Notes on 95% Accotink Gravity Sewer Plan

<https://www.accotink.org/2024/AccotinkGravitySewer95percentPlans.pdf>

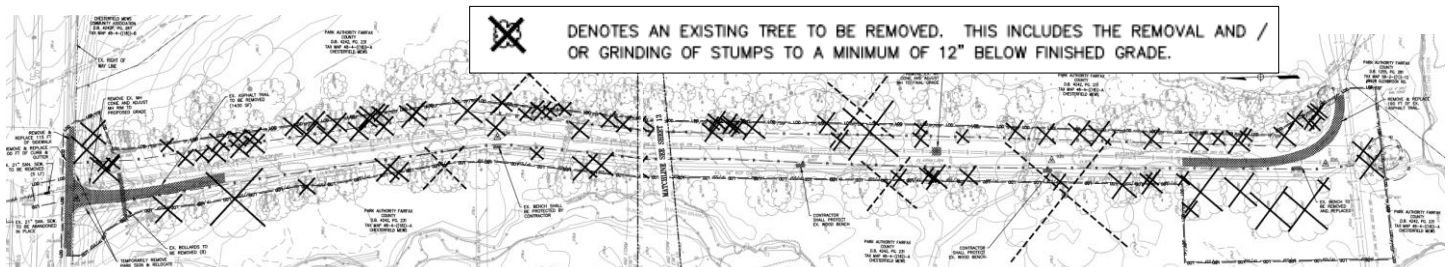
The project is RPA exempt, of course. [CBPO 118-5](#) Sheet 9

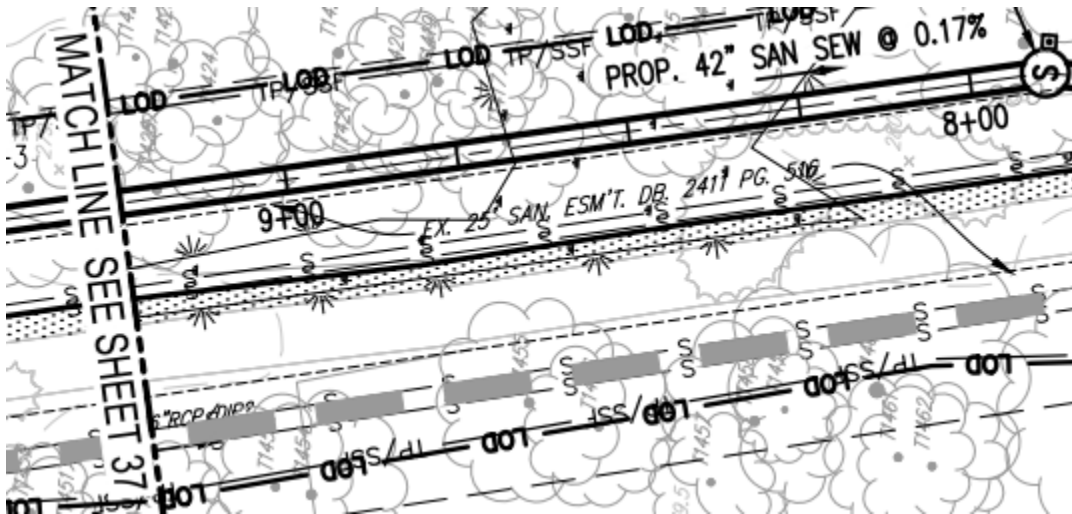
Tree toll at Accotink Trail – 95 trees of 7” or more diameter. Only those in the staging area will be replaced. The size of the “X” corresponds with the spread of the tree. Sheets 12 & 13

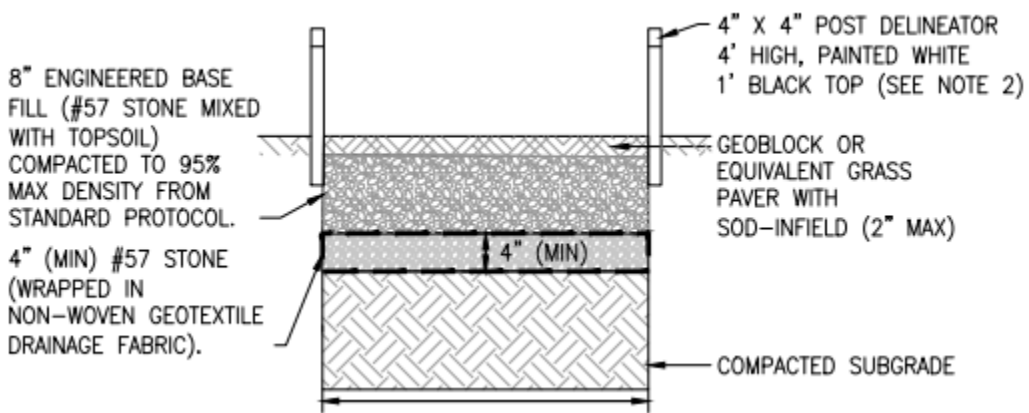
Does this refer only to the line beneath Rt. 50? If all the line south of Rt. 50 is also to be abandoned, why not replace it? Because it is easier to clear away more woods and wetlands? Sheet 68

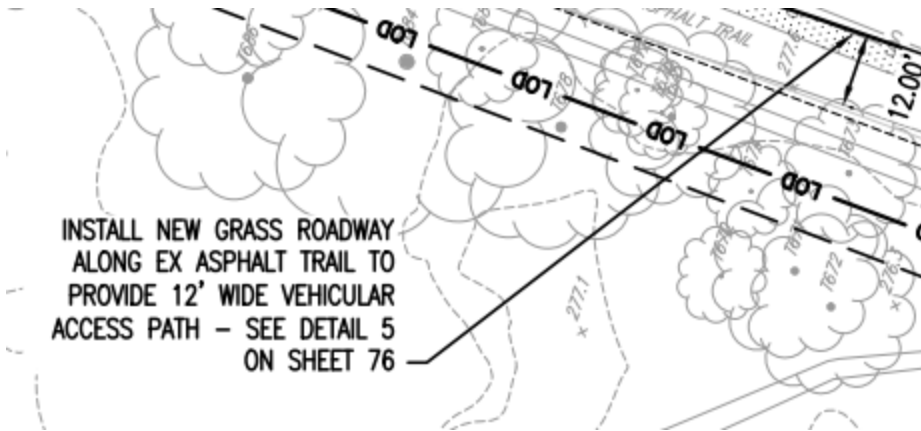
Are these two symbols equivalent? Sheet 12

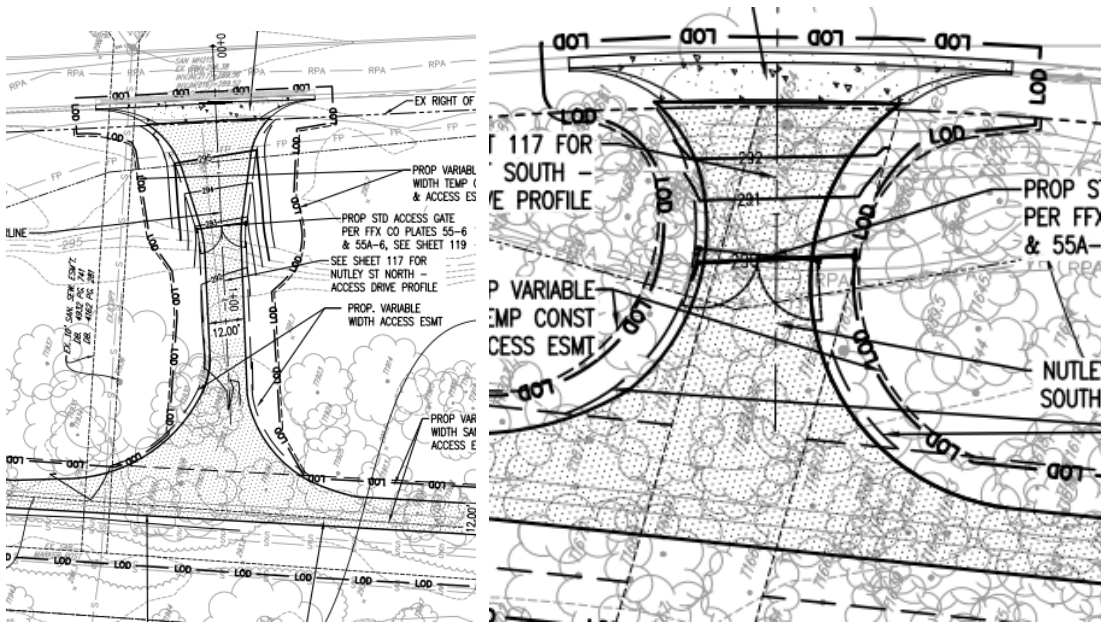
Are all the “grass” surfaces to be pavers on top of stone and geotextile? Sheet 76

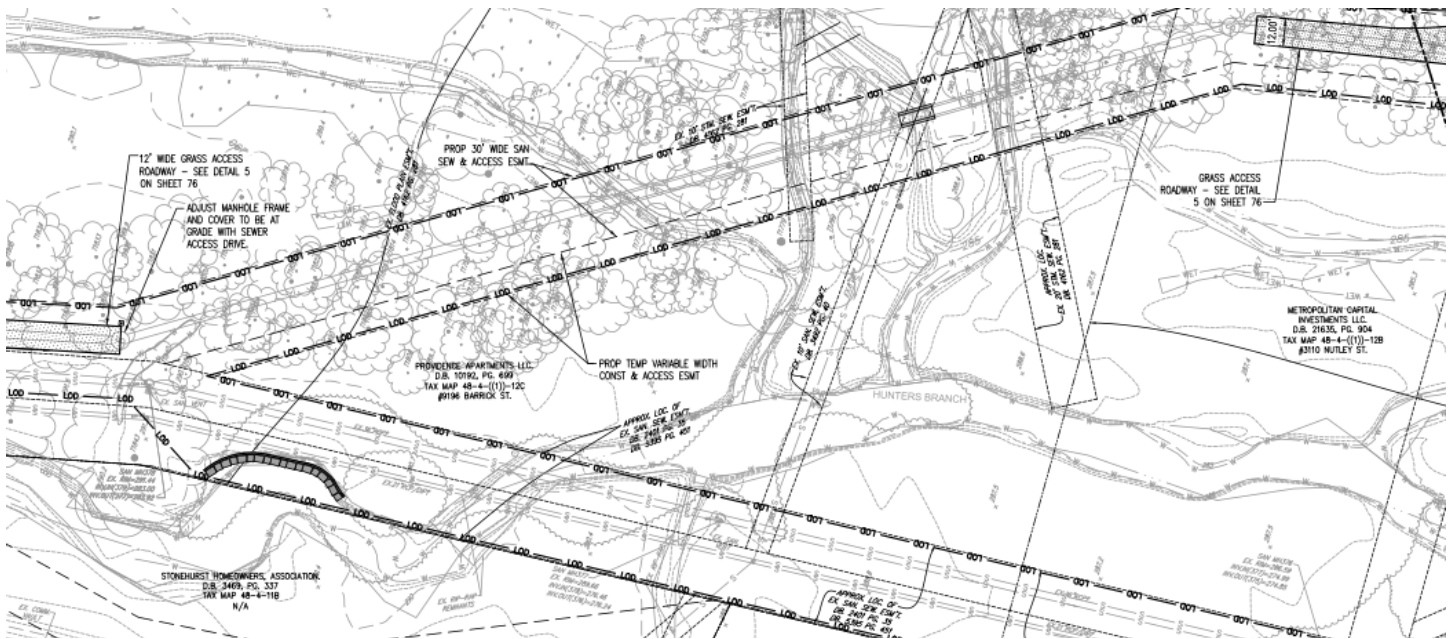
Is this 12' of grass in addition to the asphalt path south of Rt 50? Sheets 104 & 105

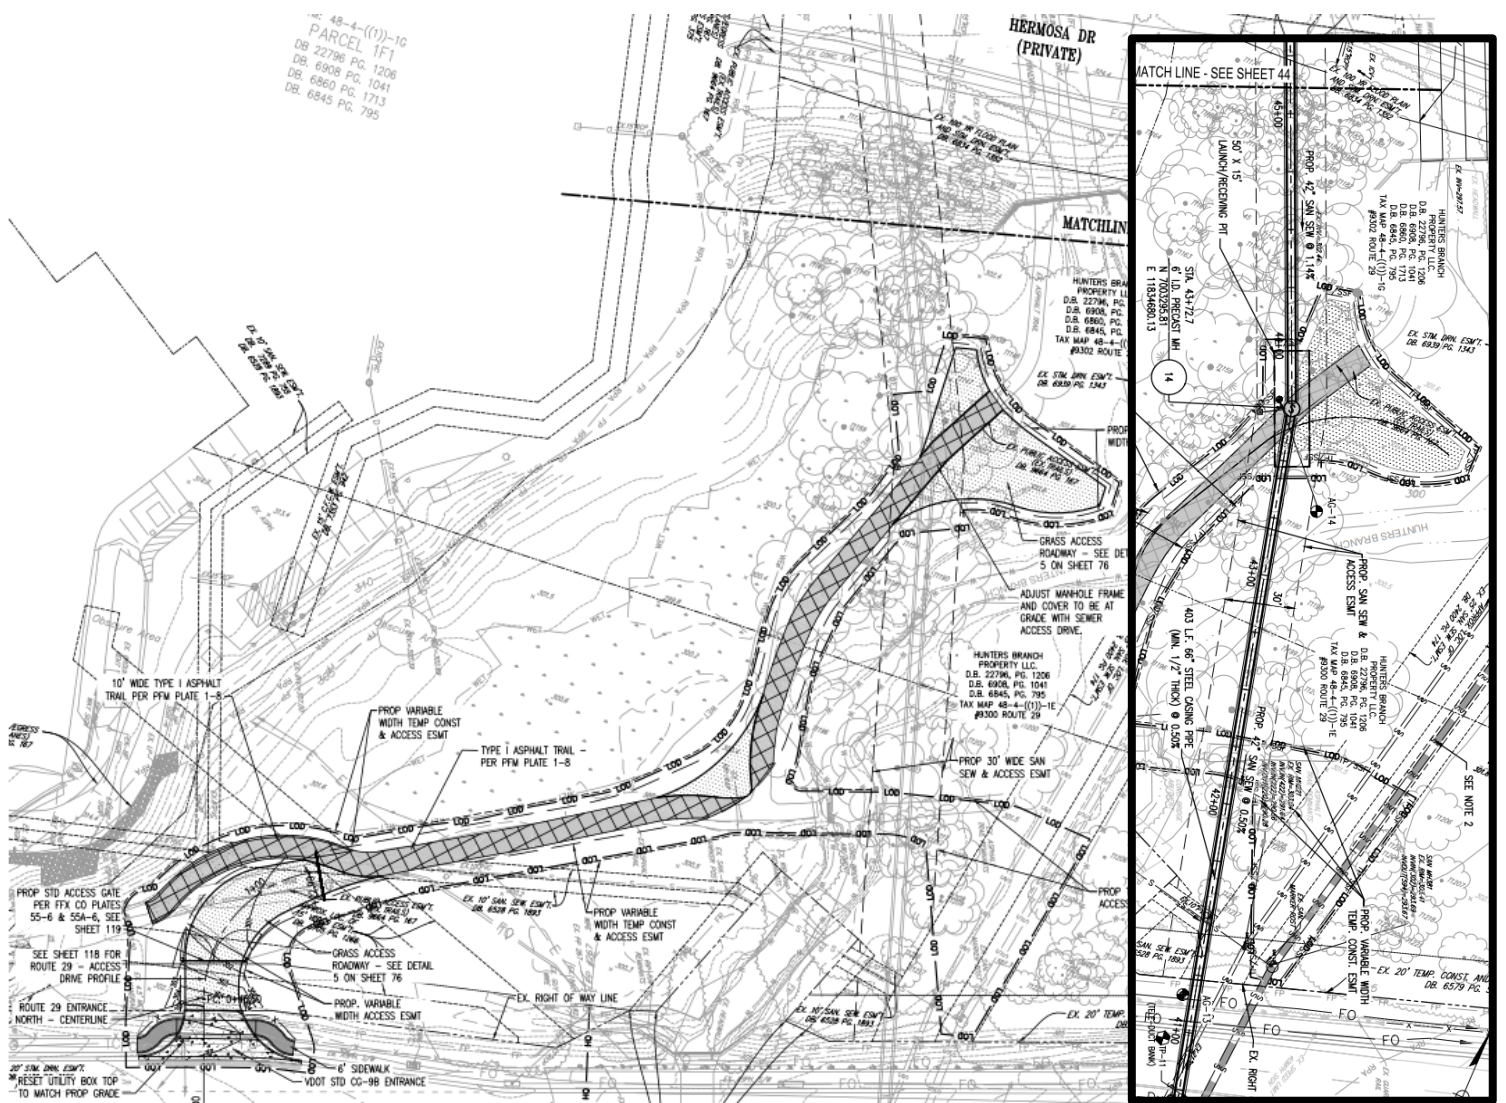
Two permanent access roads, plus 12' grass (mowed?) (not all the way?) between Rt 50 and Rt 29. Sheets 106 & 108

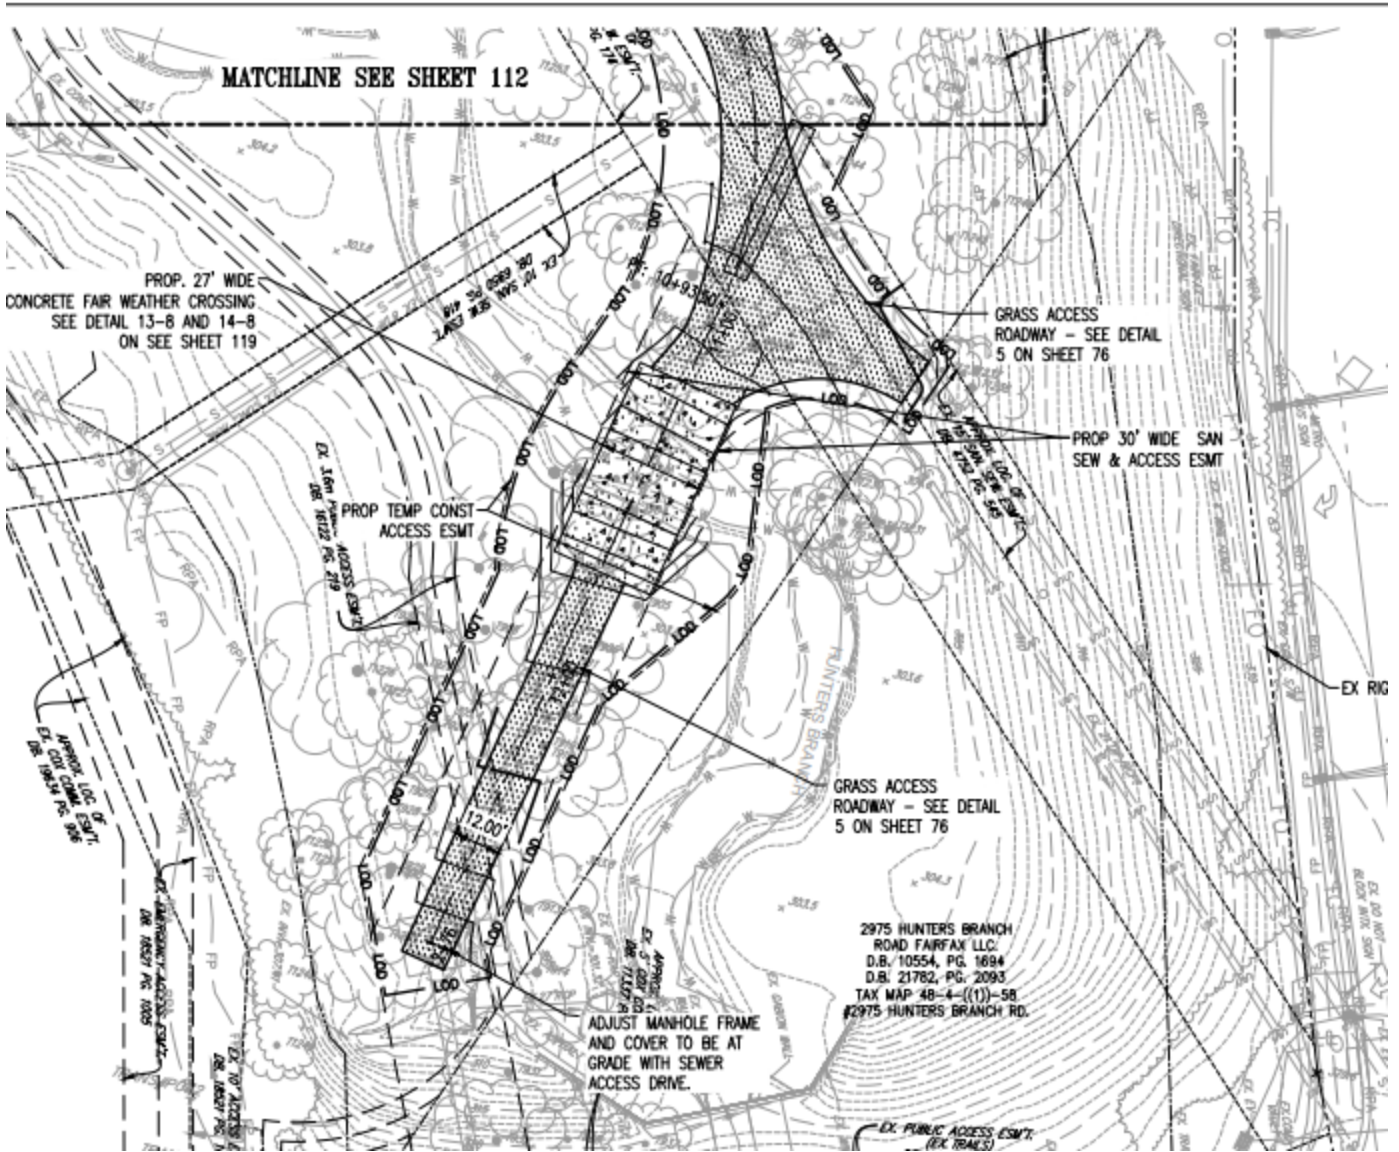
New "parallel" route diverges widely from existing sewer line – between Rt 50 & Rt 29. Sheets 106 & 107

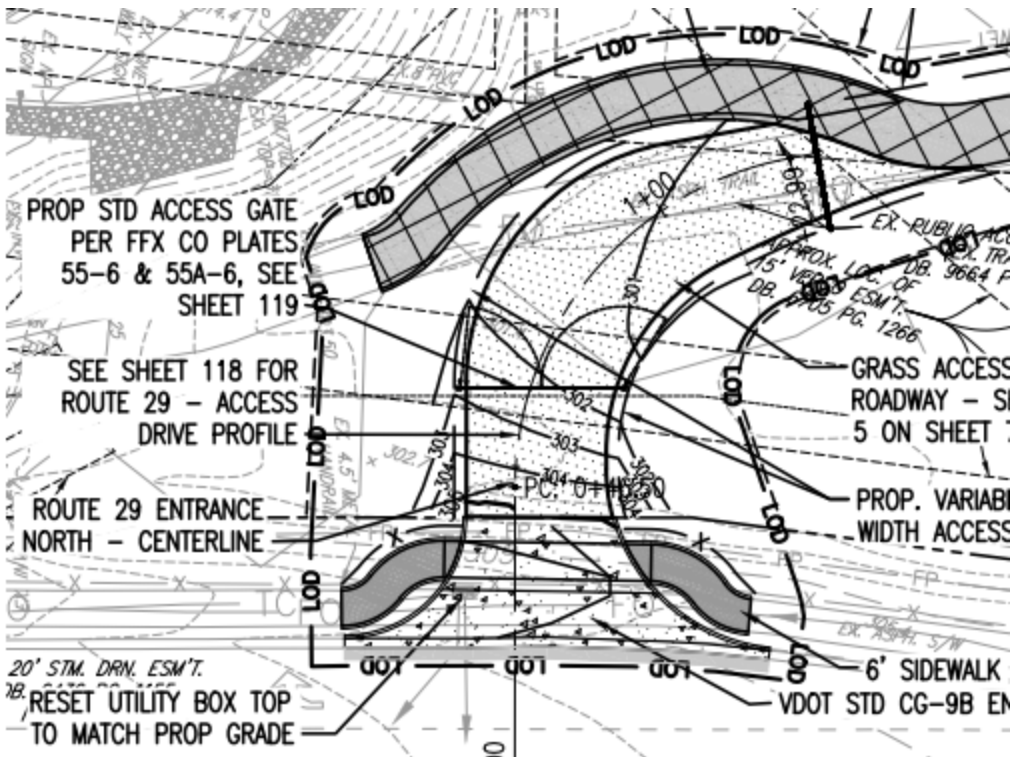
I can't see where the new sewer line goes between Rt 29 & Hermosa Dr. Or it does not have LOD marked. Sheet 110
 However, the new route is shown more clearly on the inset and also diverges widely from existing sewer line. Sheet 43

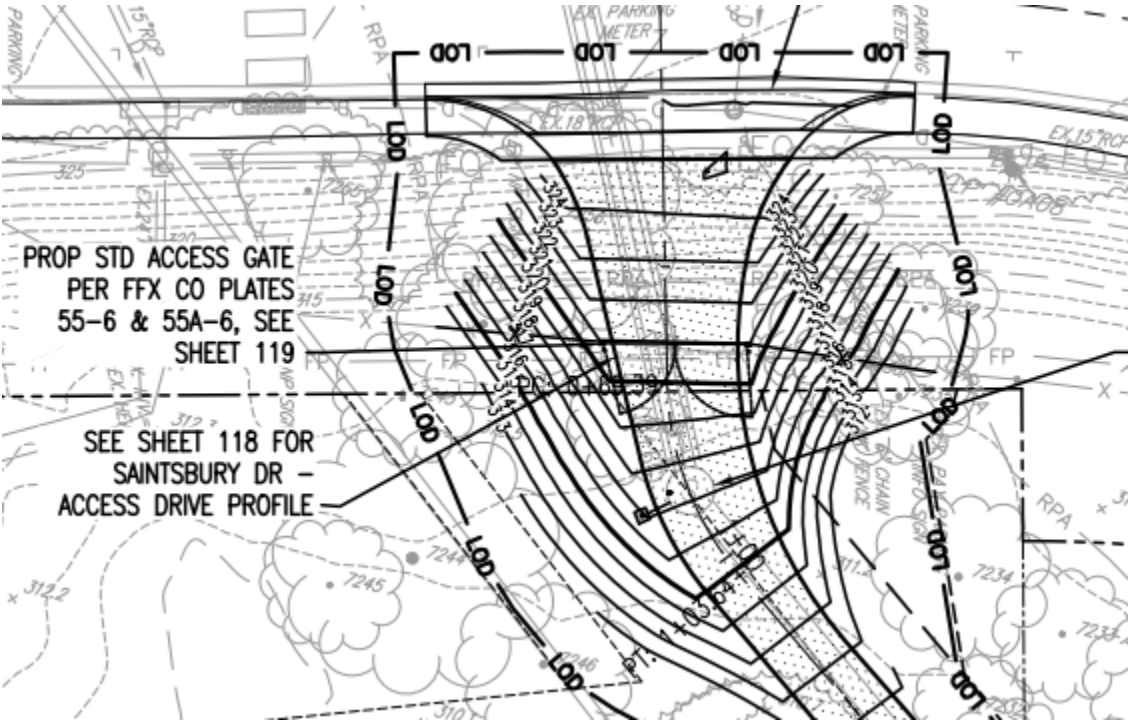
New "parallel" route diverges widely from existing sewer line – between Hermosa Drive and Saintsbury Drive. Sheet 111

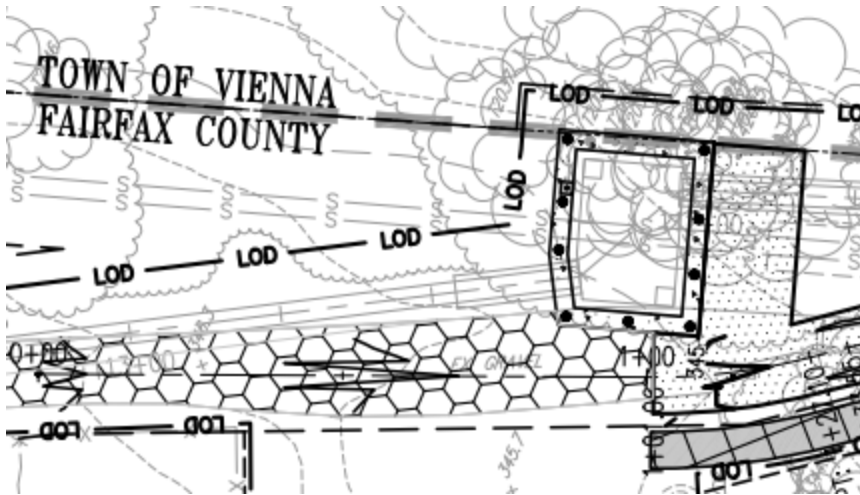
New grass access road from Rt 29 toward Hermosa Drive. Sheet 110

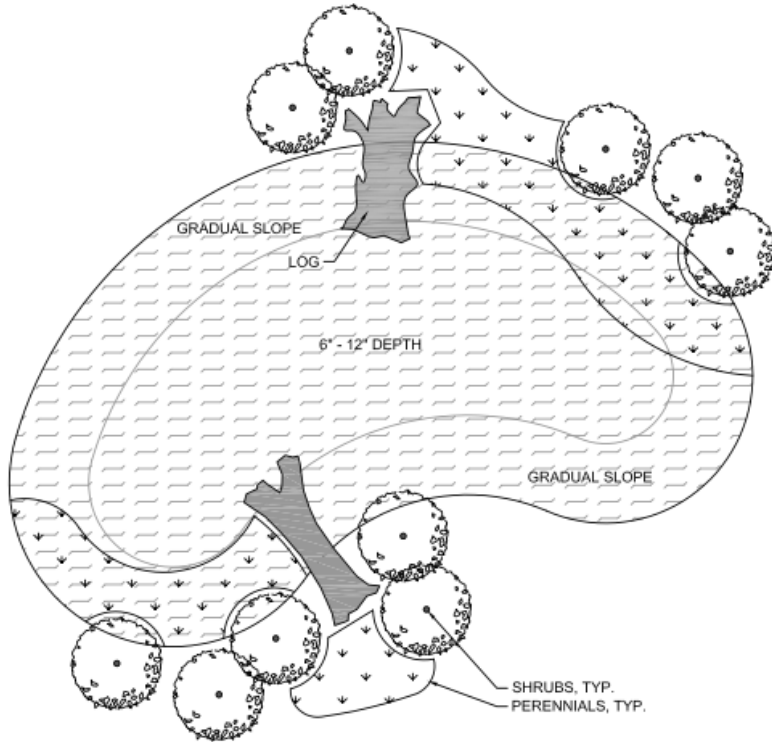
- What does “Supplemental” column mean?
- How is it possible to replace all 95 trees at Accotink Trail when only the staging area will be replanted? Sheet 162
- The replanting sheet for Nottoway Park says “No plantings provided”. Sheet 177

5 VERNAL POOL

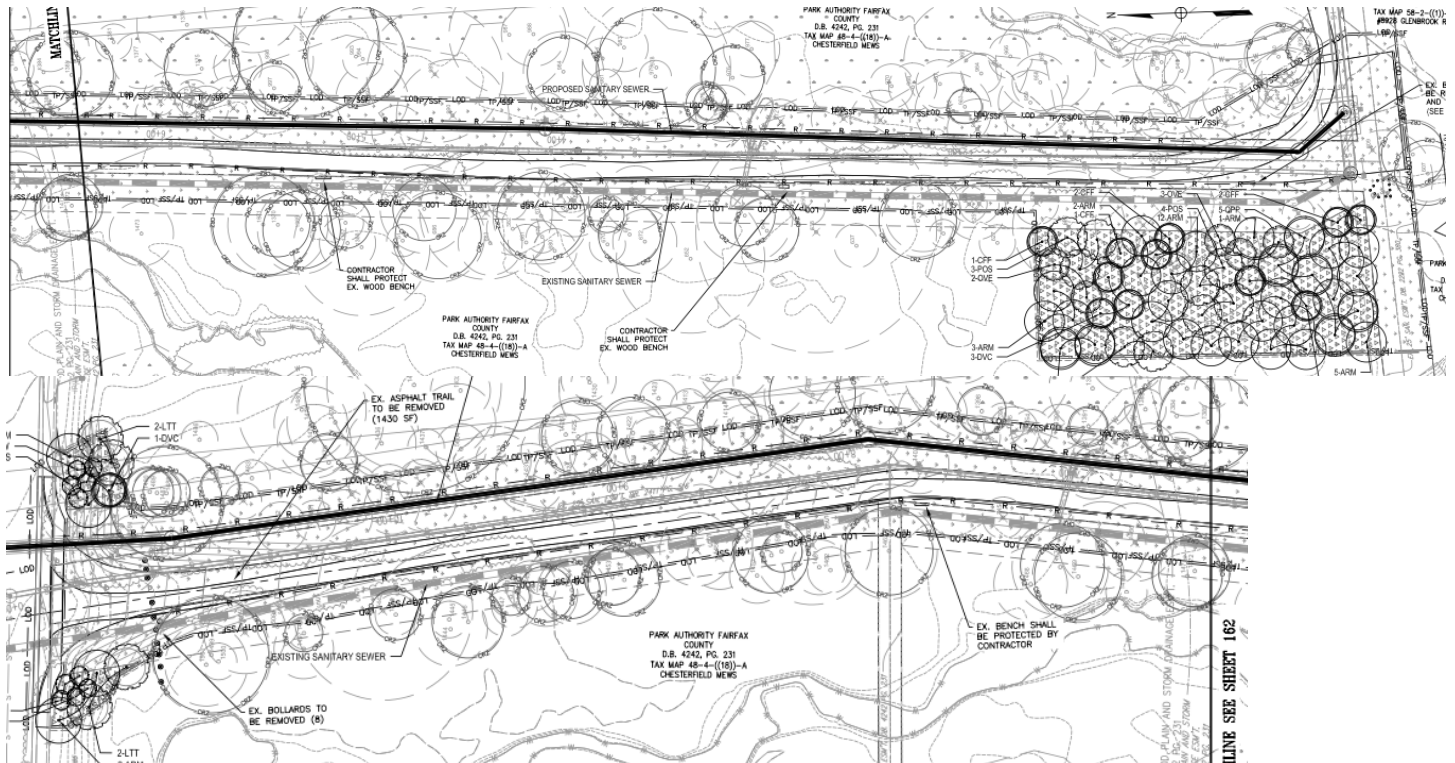
Vernal pools replacements are planned, but locations are to be determined. Sheet 160

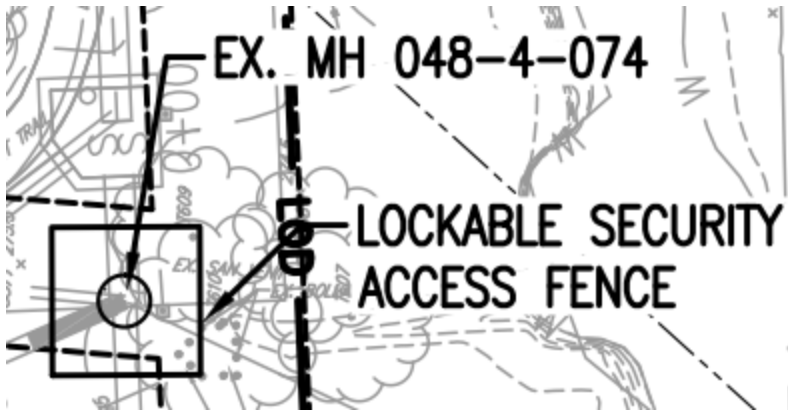
Note on areas between Nutley St. and Nottoway Park. Why? Sheets 176 & 177
